Access Compliance Report

Public Rights-of-Way

(Curb Ramps)

Intersection ID: 10031842	Main Street: MINTWORTH_AV	Cross Street: N/A	Location: NE
ADA ID: 0522193B4C4B	Ramp Type: Perp	Initial Pass/Fail: Fail	Overall Compliance: No
Severity Score: 25			
Codes/Mitigation Info/Possible Solution		Field Measurements/Component Compliance

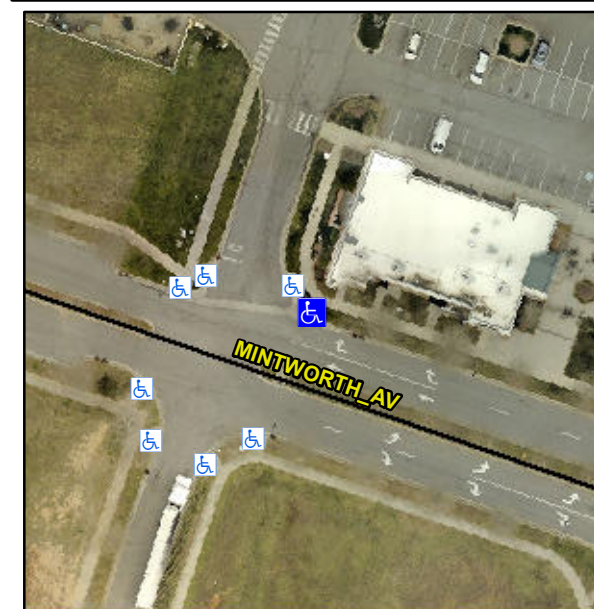
Compliance	Description	Data	Compliance	Description	Data
N/A	Ramp Length (in)	75.0	No	Ramp Slope (%)	12.0
Yes	Ramp Width (in)	48.0	Yes	Ramp XSlope (%)	1.3
N/A	Flare Type LT	N/A	N/A	Flare Type RT	N/A
N/A	Flare Slope LT (%)	N/A	N/A	Flare Slope RT (%)	N/A
N/A	Flare Traversable LT?	N/A	N/A	Flare Traversable RT?	N/A
N/A	Landing Length (in)	N/A	N/A	DWS Provided?	N/A
N/A	Landing Width (in)	N/A	N/A	DWS Contrast?	N/A
N/A	Landing Slope (%)	N/A	N/A	DWS Length (in)	N/A
N/A	Landing X Slope (%)	N/A	N/A	DWS Full Width?	N/A
N/A	Landing Curb? (Y/N)	N/A	N/A	DWS Offset (in)	N/A
N/A	Shared Landing?	N/A			
N/A	Gutter Ponding?	N/A	N/A	Gutter Slope (%)	N/A
N/A	Gutter Lip Ht (in)	N/A	N/A	Gutter X Slope (%)	N/A
N/A	Painted X Walk1?	No	N/A	Painted X Walk2?	N/A
	X Walk 1 Direction	To SW		X Walk 2 Direction	N/A
N/A	X Walk 1 Width (in)	N/A	N/A	X Walk 2 Width (in)	N/A
	X Walk 1 Slope (%)	1.6		X Walk 2 Slope (%)	N/A
	X Walk 1 X Slope (%)	0.5		X Walk 2 X Slope (%)	N/A

Remove & Replace Entire Ramp.
